SUBJECT: Scoping Notification/Solicitation of Views

RE: St. James Parish Drainage Improvements – Project 1603-0221

RE: 101020/2190 Grand Point Bourbon subdivision drainage improvements  
 FEMA funding  
 St. James Parish

RE: Submittal of draft Management Summary "*Phase I Cultural Resources Survey of the Longview Canal Drainage Project, St. James Parish, Louisiana*", as part of the Hazardous Mitigation Grant Program

**Figure 1.2** Excerpt from the 1996 digital 7.5' series USGS, Louisiana, topographic quadrangle depicting the location of the St. James Parish Drainage Improvement Project (Longview Canal) APE (in red), Grand Bourbon subdivision, and the St. James Parish Canal.

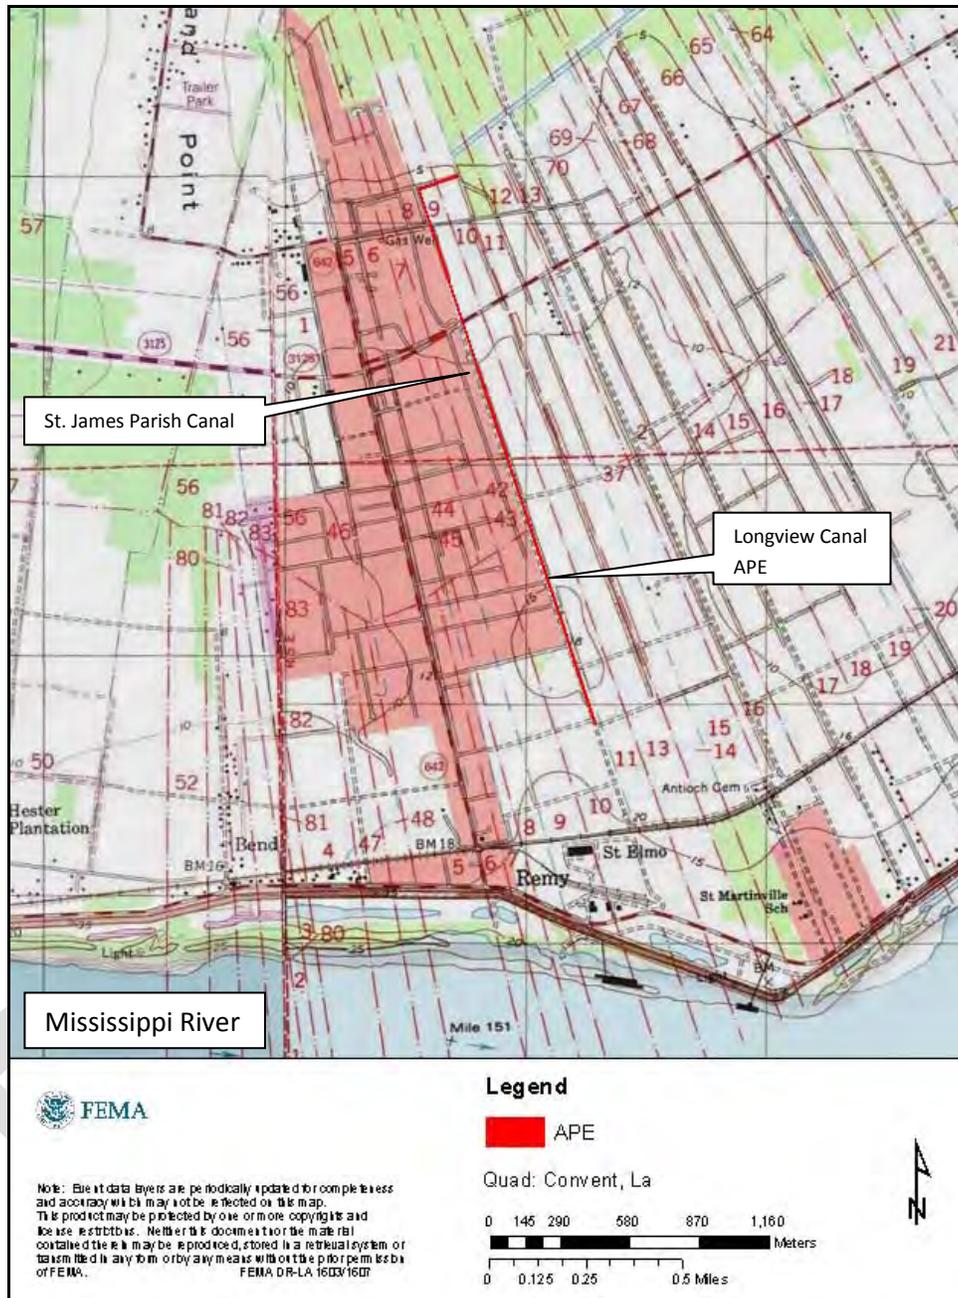
2. Figure 1 and 2. Please enlarge these figures to a 1:24,000 scale, per LDOA Standards. This will make the project area more clear. Also, label the Mississippi River in Figure 1 and, if feasible, include it in Figure 2. Also, please provide an inset map indicating the map area in relationship to the State of Louisiana and provide the name and date of the 7.5 USGS Quad used as the background.

**Figure 6.1 Shovel test locations in the vicinity of 16SJ12 (STPs not labeled due to scale and legibility).**

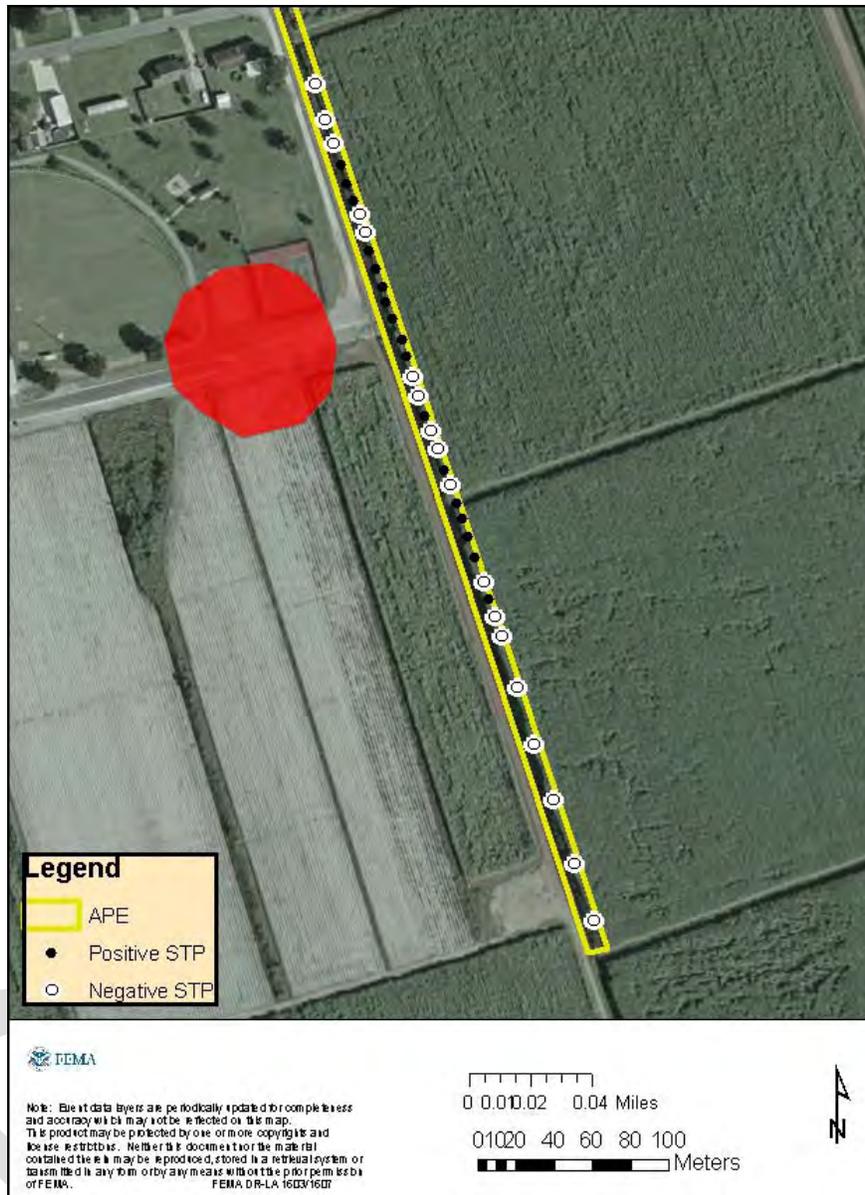
11. Page 11, Figure 6. This figure should be enlarged. There is no practical way to see the STP Locations or the lettering which denotes something. What is the difference between black and red? Assuming red to be positive, is there clustering? Can it be linked to historic maps?

15. Page 16, Auger Tests. From where were the auger tests excavated?
16. Page 17, Figure 13. Please enlarge, but of less importance than enlarging Figure 6.

**Figure 6.7** Metal artifacts recovered from 16SJ12 testing: a and b) two iron spikes and c) one wire nail fragment.

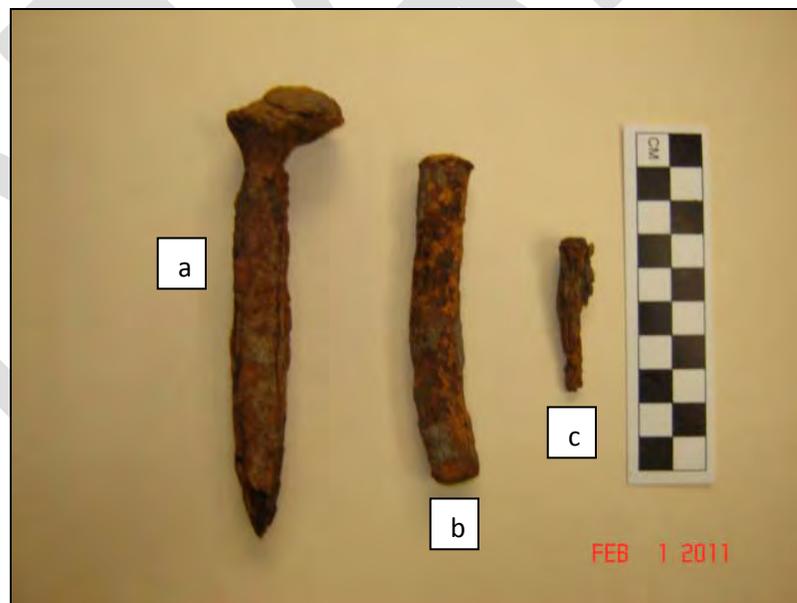
14. Figures 9, 10 and 12. When describing the artifacts, dispense with the use of the word "type" and do not follow the closing parenthesis with a period. This will clarify the textural description.
